Line 5 Reroute

Clean Water Act Section 401(a)(2) Hearing

Ian Paton, P.E., CPESC

Results for HDD IR for the Bad River - from Enbridge Consultant:

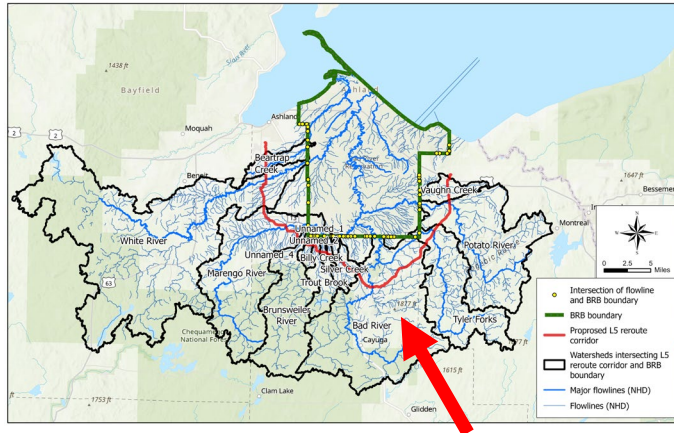
“By 2,000 m (or 2 km) downstream, TSS predictions for all scenarios were below the calculated threshold of 19 mg/L identified for this study. Therefore, TSS concentrations would likely fall below this threshold by the time suspended sediments reached the Reservation boundary (approximately 19.5 km downstream from the Proposed Route crossing).”

(Note: 19 mg/L TSS was calculated by Enbridge consultant as approximately equal to 5 NTU Bad River water quality standard for increased turbidity)

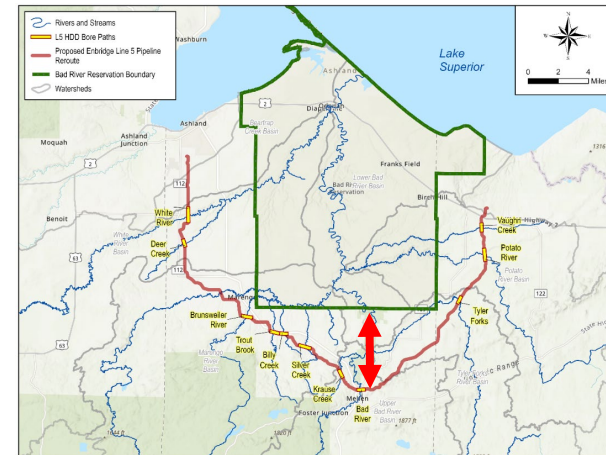
ii) The Bad River HDD location is further away from the Reservation boundary than all the other HDD locations

- Bad River HDD location provides greater time for suspended solids to settle out from an HDD IR before reaching the Reservation boundary compared to other HDD locations.

Examples
Distance from
BRB Reservation
boundary:

Bad River HDD:
12.3 miles

Billy Creek HDD:
2.2 miles

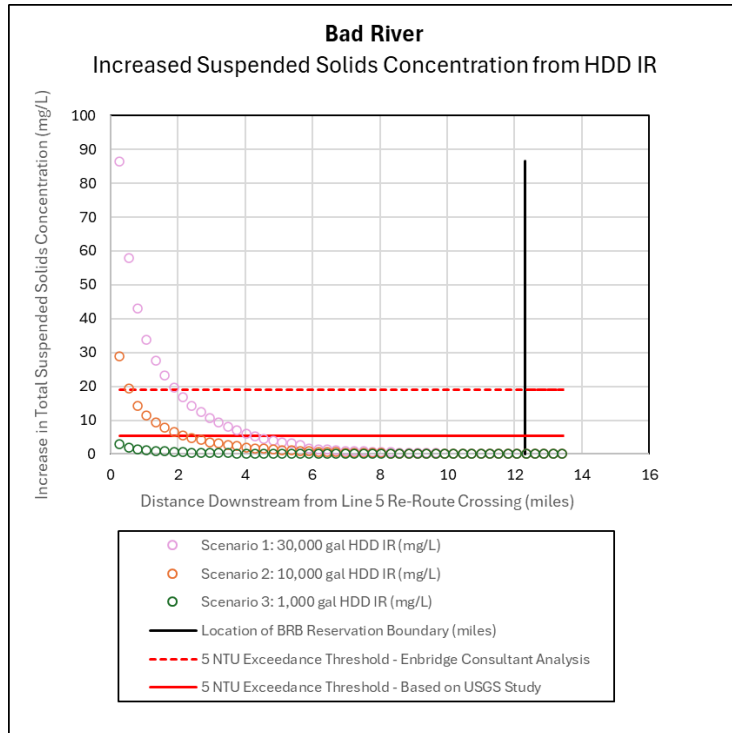
The TSS/NTU relationship for the Bad River cannot be assumed to be applicable to other watercourses.

The TSS/NTU relationship is well documented to vary widely from one watercourse to another:

"It should also be noted that the proportionality of the linear relationship represented as the ratio of TSS to turbidity (in terms of mg/L over NTU) varied between 0.64~3.4 as determined through our literature search."
